UNITED STATES PATENT AND TRADEMARK OFFICE

APPLICATION NO.	FILING DATE	FIRST NAMED INVENTOR	ATTORNEY DOCKET NO.	CONFIRMATION NO.
09/430,132	10/09/1987	Keith A. Snail	70,840	6820
7590 12/10/2004				
THOMAS E. McDONNELL Department of the Navy Ballston Centre Tower Research 800 N. Quincy Street Arlington, VA 22217			EXAMINER STAFIRA, MICHAEL PATRICK	
			ART UNIT 2877	PAPER NUMBER
DATE MAILED: 12/10/2004

Office Action Summary	Application No. 09/430,132	Applicant(s) SNAIL ET AL.	
	Examiner Michael P. Stafira	Art Unit 2877

Claim 1

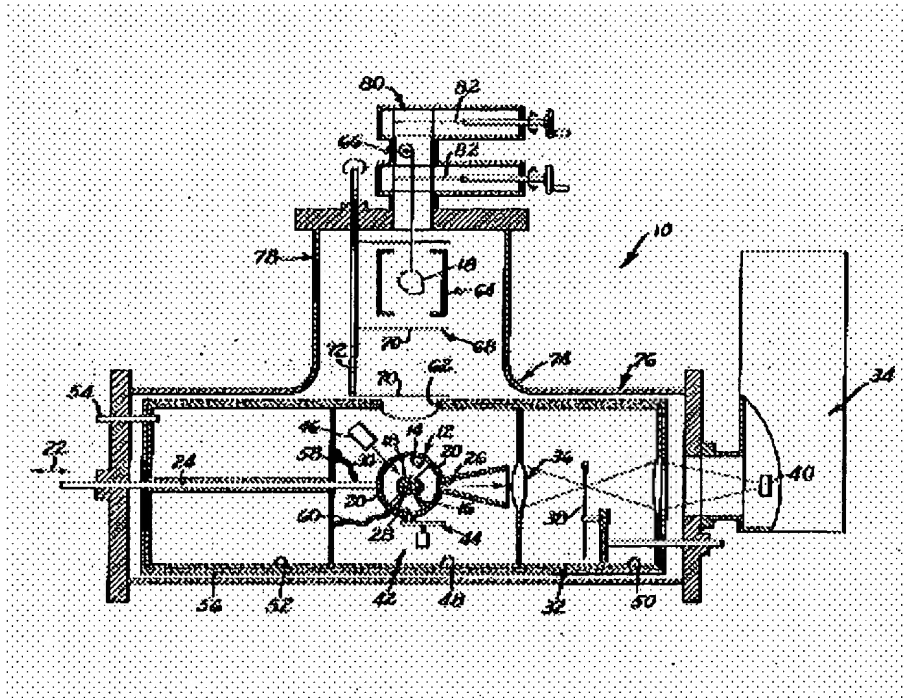
6. Claim 1 is rejected under 35 U.S.C. 102(b) as being anticipated by Sparks ('809).

Sparks ('809) discloses an integrating sphere (Fig. 1, Ref. 12)(Col. 1, lines 23-27); an airtight chamber means (Fig. 1, REF. 48, 50, 52) effective to provide the inside of said chamber means with a non-air atmosphere of preselected composition (Col. 5, lines 55-67)(Col. 7, lines 15-18); and a means for mounting a sample inside said integrating sphere (Fig. 1, Ref. 16).

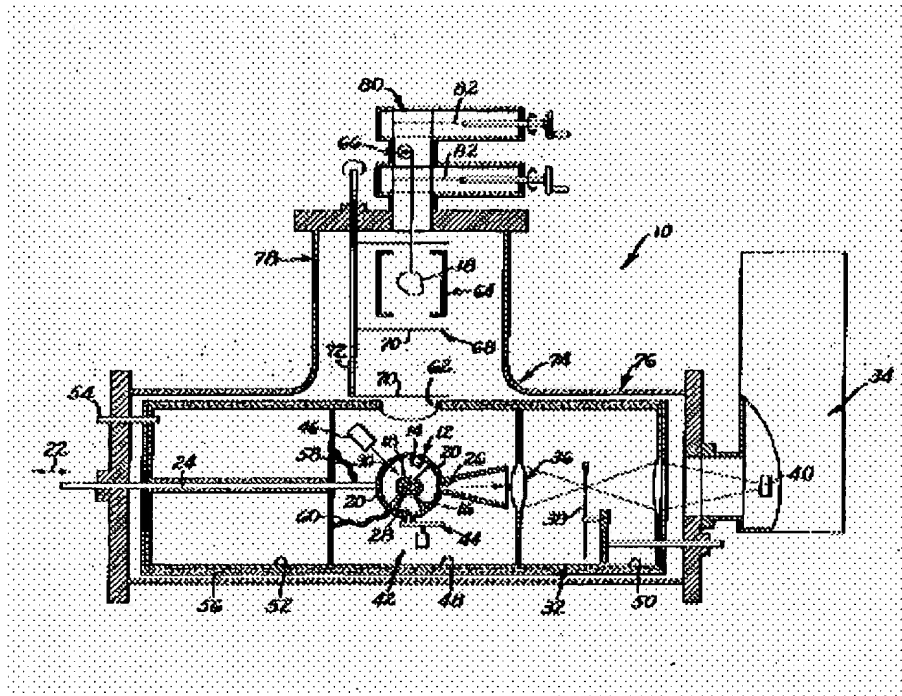
Sparks ('809) discloses an integrating sphere (Fig. 1, Ref. 12), said sphere having a wall and a port means (Fig. 1, Ref. 30) for passing light flux (Fig. 1, Ref. 46) from the inside of said sphere to the outside (Fig. 1, Ref. 26), a means for mounting a sample (Fig. 1, Ref. 16) effective to expose at least a portion of the sample to light flux exiting from the interior.

Sparks ('809) discloses the claimed invention except for clamping means. It would have been obvious to one having ordinary skill in the art at the time the invention was made to combine Sparks ('809) with the clamping means since it was well known in the art that using a

clamping means provides a securing means that prevents the sample from moving when unpredicted force is applied to the chamber, therefore increasing the reliability of the measurement.
